**REMARKS/ARGUMENTS**

Serial Number 09/907,260  
Amdt. Dated August 15, 2003  
Reply to Office action of April 15, 2003

Docket 106E-0023CIP

Appl. No. 09/907,260  
Amdt. Dated August 15, 2003  
Reply to Office action of 4/15/03  
Annotated Sheet Showing Changes

**Fig. 2**

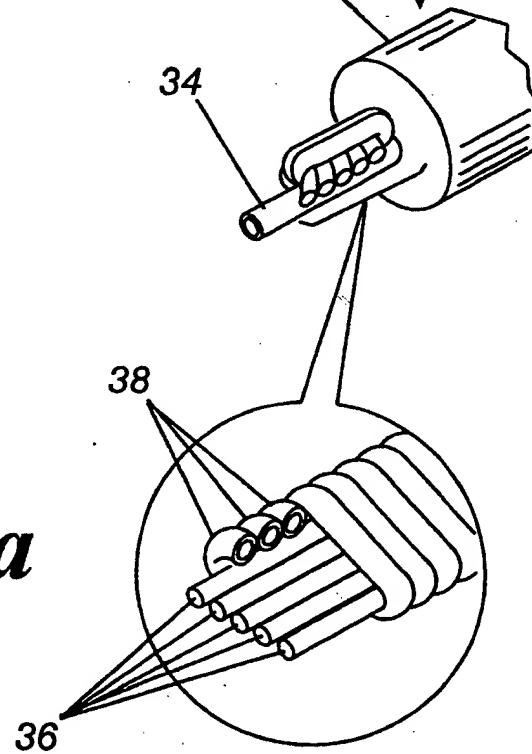
In amended Figure 2, the previously omitted element numeral 39 has been added.
